**ADDENDUM TO THE INITIAL STUDY / MITIGATED NEGATIVE DECLARATION
FOR THE 2ND AND VIGNES PROJECT
929-939 E. 2ND STREET
LOS ANGELES, CA 90012
CASE NO. ENV-2016-1081-MND**

2nd and Vignes (the Modified Project)

Figure 4
Building Section

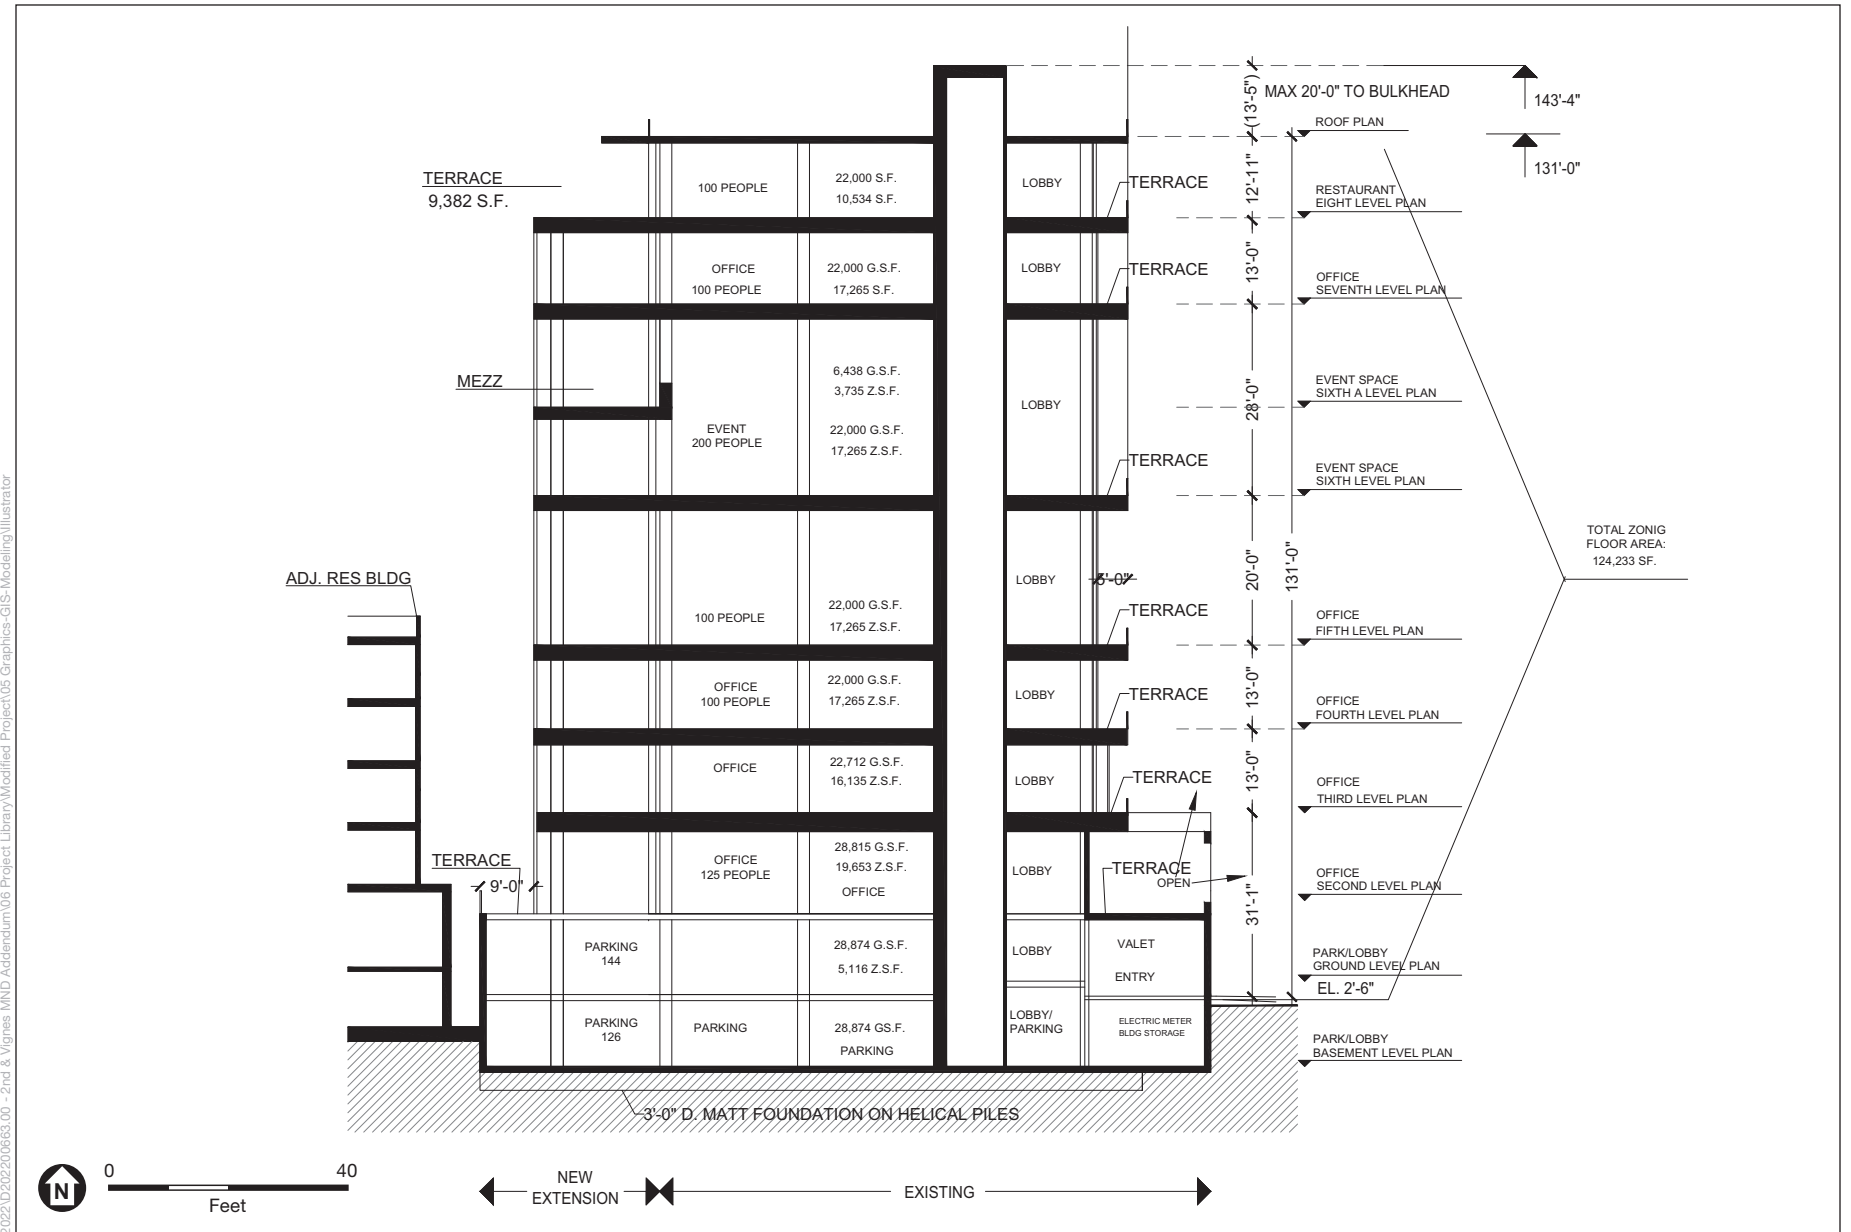
The Project Applicant is proposing a modified project that would maintain the Approved Project's building height. The Modified Project consists of a renovation to the existing two-story commercial building with one subterranean level with the addition of six new levels above the existing building to create an eight-story, 131-foot high, 124,233-square-foot commercial development; refer to **Figure 3, Project Site Plan** and **Figure 4, Building Section**. Additionally, the Modified Project would enhance the neighborhood aesthetics by relocating the parking (which will no longer be a mechanical automated parking system) from the fourth level of the building to the first level and basement level to create additional office space. The fourth level (which would now become two levels, the fourth level and fifth level) would now consist of office uses, art/photo studios, and screening room uses. When compared to the 33,961 square feet of office uses of the Approved Project, the Modified Project proposes 70,318 square feet of office uses resulting in the additional 36,357 square feet of office space. The Modified Project proposes 270 on-site vehicle spaces, 42 long-term bicycle spaces, and 19 short-term bicycle spaces resulting in an additional 29 on-site vehicle parking spaces, an additional 22 long-term bicycle spaces, and one less short-term bicycle space when compared to the Approved Project. Further, the Modified Project proposes 24,547 square feet of open space, resulting in an additional 8,844 square feet of open space compared to the Approved Project. In addition to the relocation of parking in the building, the Modified Project would add approximately 21,544 square feet of additional floor area, resulting in a total floor area of 124,233 square feet; please refer to **Table 1, Comparisons of Approved Project and Modified Project**. The Modified Project would maintain the current land use designation and zoning classification, but would change the Qualified Classification (Q Classification) to allow the increase in floor area of 21,544 square feet. The construction of the Modified Project is similar to the Approved

**TABLE 1
COMPARISONS OF APPROVED PROJECT AND MODIFIED PROJECT**
